HPB23-0575
September 12, 2023

LINCOLN ROAD RENEWAL

Easier Pedestrian Beach Access

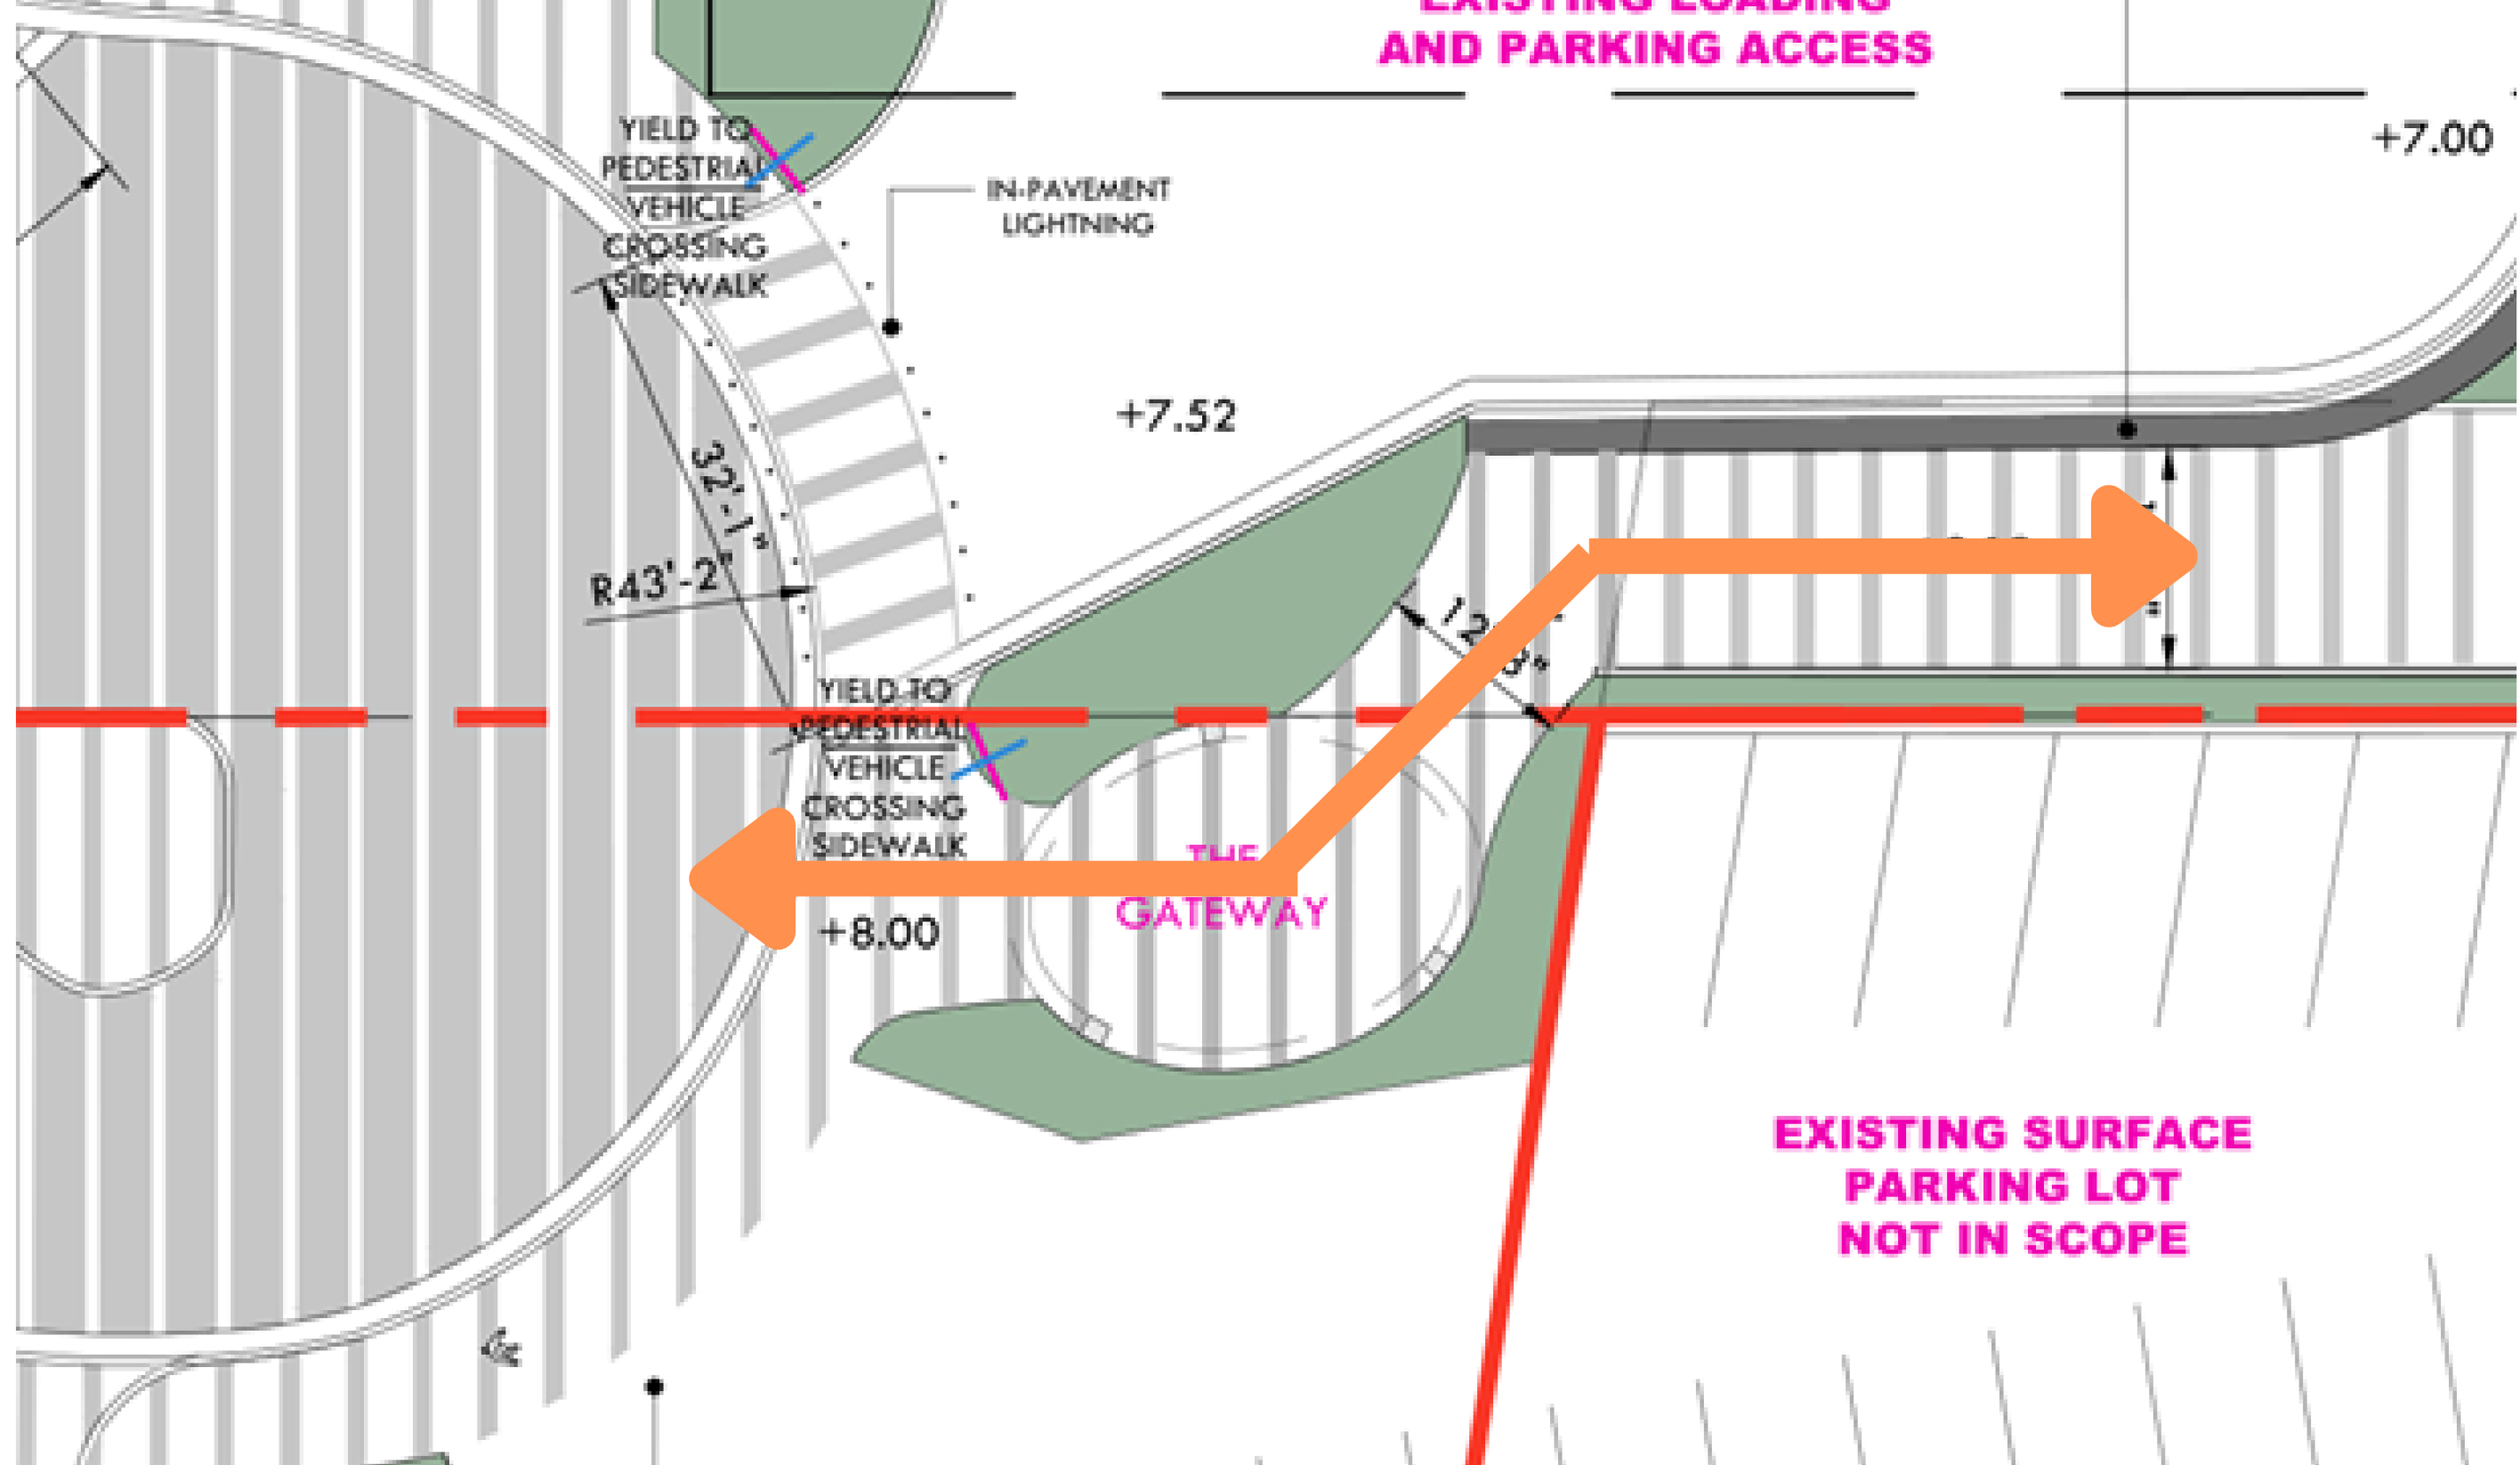
Staff is extremely supportive of the proposed improvements to this highly traveled corridor which will enhance the pedestrian experience and will reduce potential conflicts with pedestrians, bicyclists, and vehicles. The proposed plan will also substantially improve the existing loading conditions of the hotel. Additionally, staff appreciates the design of the decorative paving pattern proposed for the vehicular and pedestrian surfaces which has been inspired by the Morris Lapidus piano key design of Lincoln Road Mall.

At the end of the Lincoln Road right-of-way, the applicant is proposing to introduce a gateway element inspired by the Morris Lapidus designed folly structures of the Lincoln Road Mall. This gateway area also serves as the connection between Lincoln Road and the Beachwalk. Staff is generally supportive of the gateway design; however, staff recommends that the paving be expanded to the north to provide a safer and smoother transition (especially for bicyclists) from Lincoln Road to the Beachwalk.

generally supportive of the gateway design; however, staff recommends that the paving be expanded to the north to provide a safer and smoother transition (especially for bicyclists) from Lincoln Road to the Beachwalk.

1. Revised elevation, site plan and floor plan drawings shall be submitted and, at a minimum, such drawings shall incorporate the following:
 - a. The pedestrian walkway paving shall be expanded to the north of the gateway structure to provide a smoother transition from Lincoln Road to the path to the Beachwalk, in a manner to be reviewed and approved by staff consistent with the Certificate of Appropriateness Criteria and/or the directions from the Board.

- b. The final design and details of the roadway configuration and on street parking and loading spaces shall be provided, in a manner to be reviewed and approved by staff consistent with the Certificate of Appropriateness Criteria and/or the directions from the Board and shall be subject to the review and approval of the Transportation and Parking Departments and all other applicable departments.

- c. The applicant shall revise the lane marking to remove the right-turn markings shown on the outside lane into the Decoplage Condominium in a manner to for all the design vehicles while keeping the traffic circle to the minimum radius and maximizing the pedestrian sidewalk width. In addition, the applicant shall modify the landscaping to minimize the deflection angle near the gateway, in a manner to be reviewed and approved by staff consistent with the Certificate of Appropriateness Criteria and/or the directions from the Board and all other applicable departments.

Maneuverability Analysis (SU40)

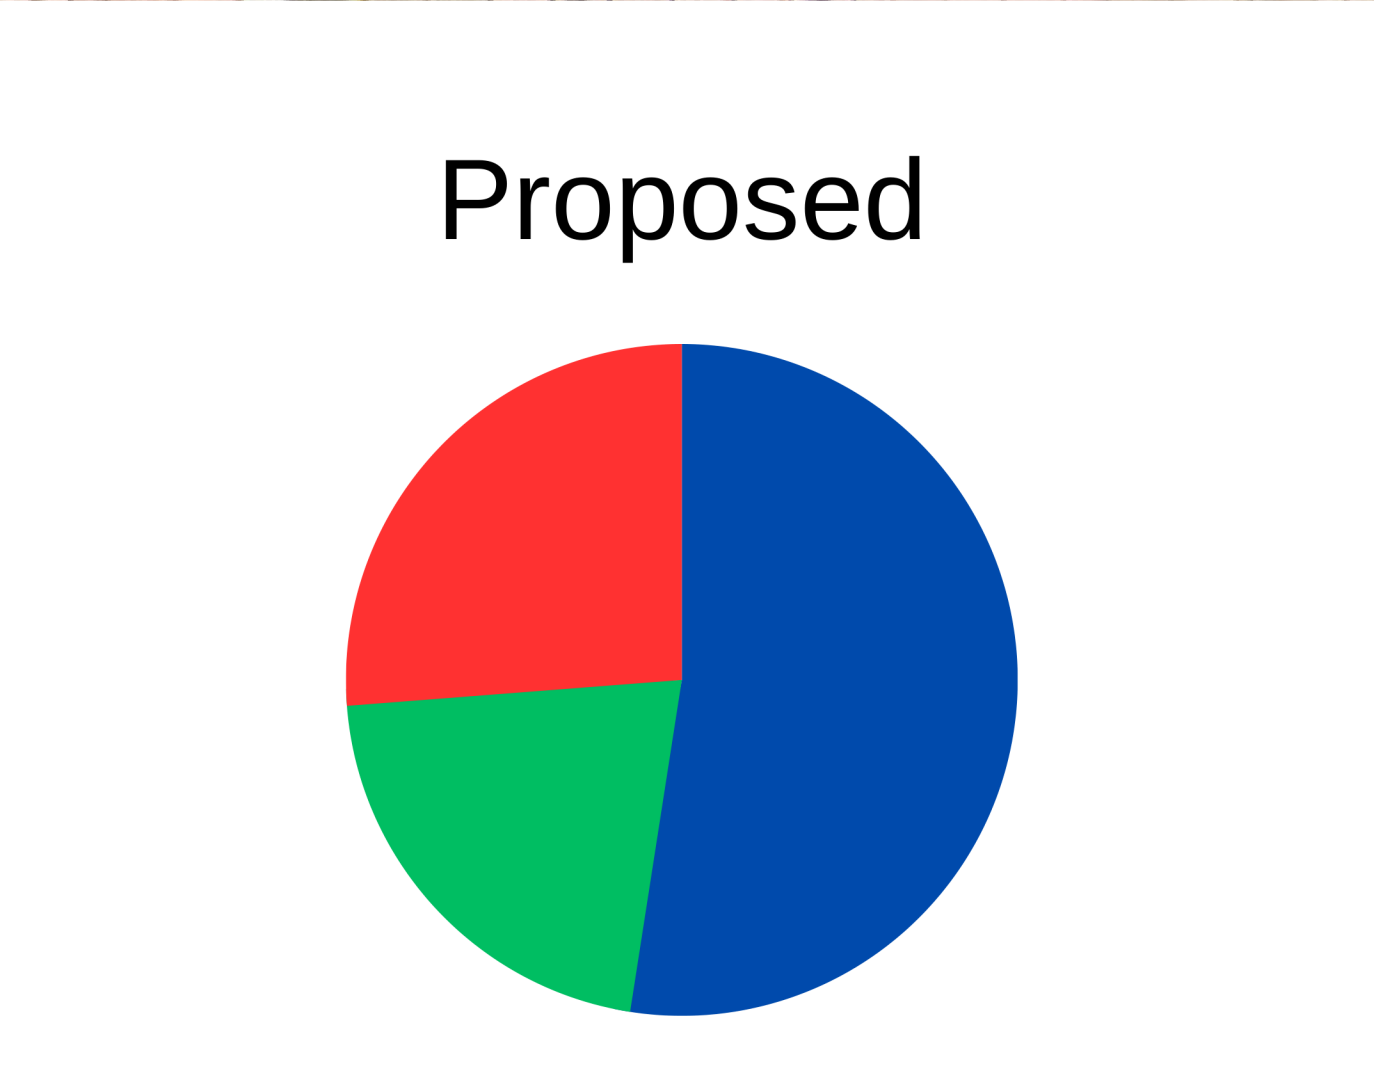
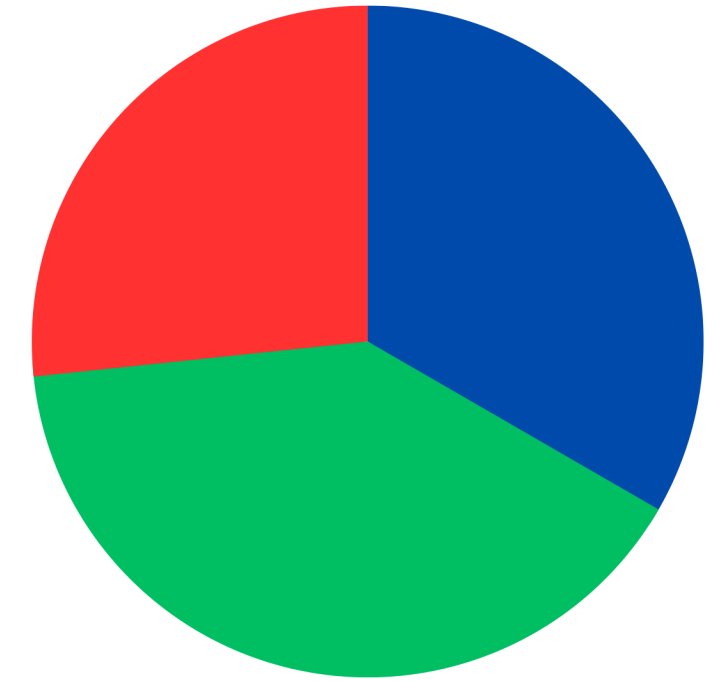
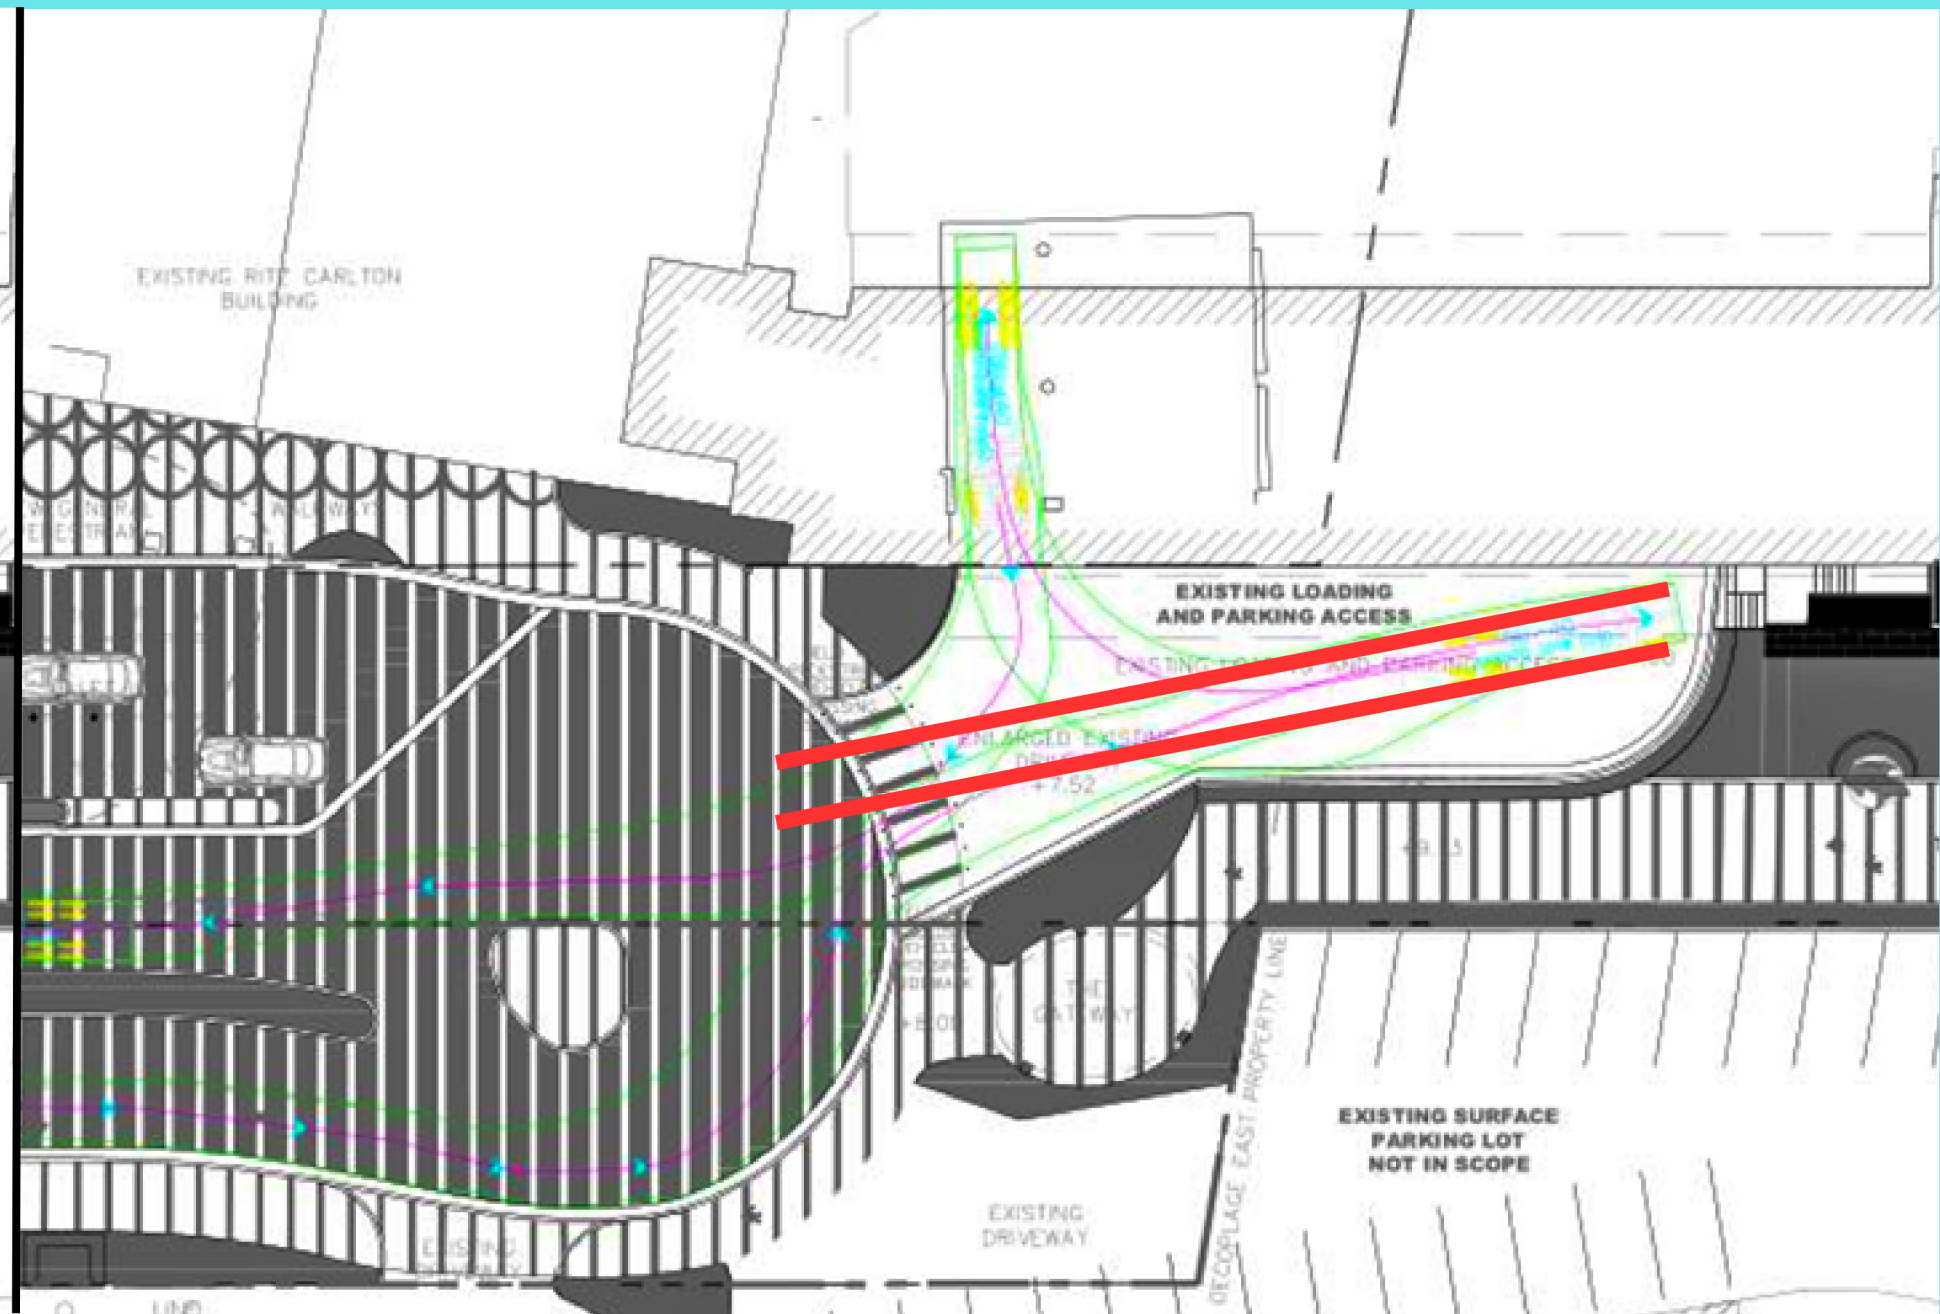
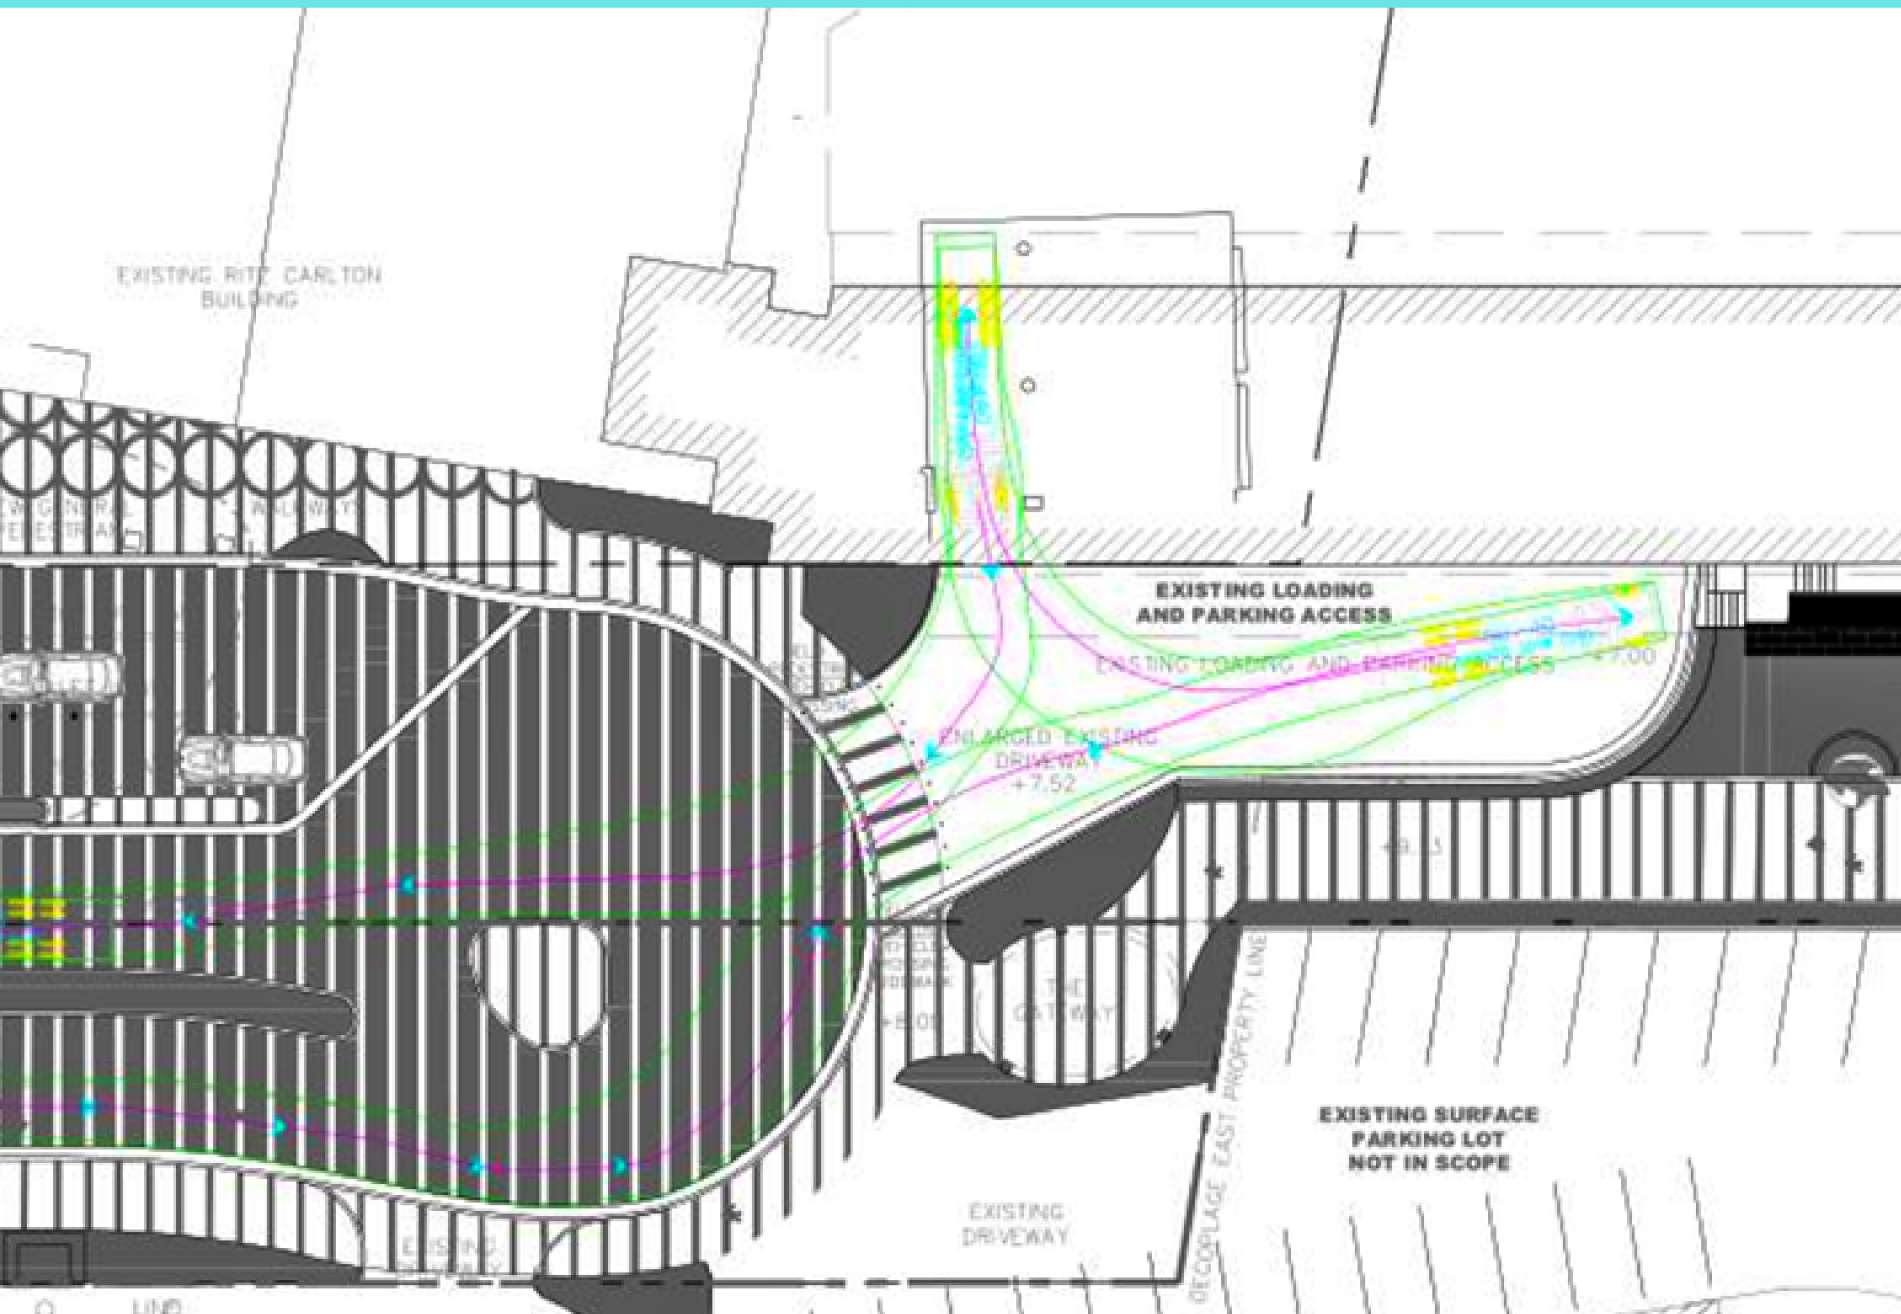
32 Feet (Proposed)

Less Than 32 Feet
(Alternative)

Loading Driveway width increases from 20' to 32'

Beach access path, at street end, decreases from approx. 24' to 13'

Direct applicant to work with stakeholders & staff to refine street-end design to be more appropriate and balanced than proposed
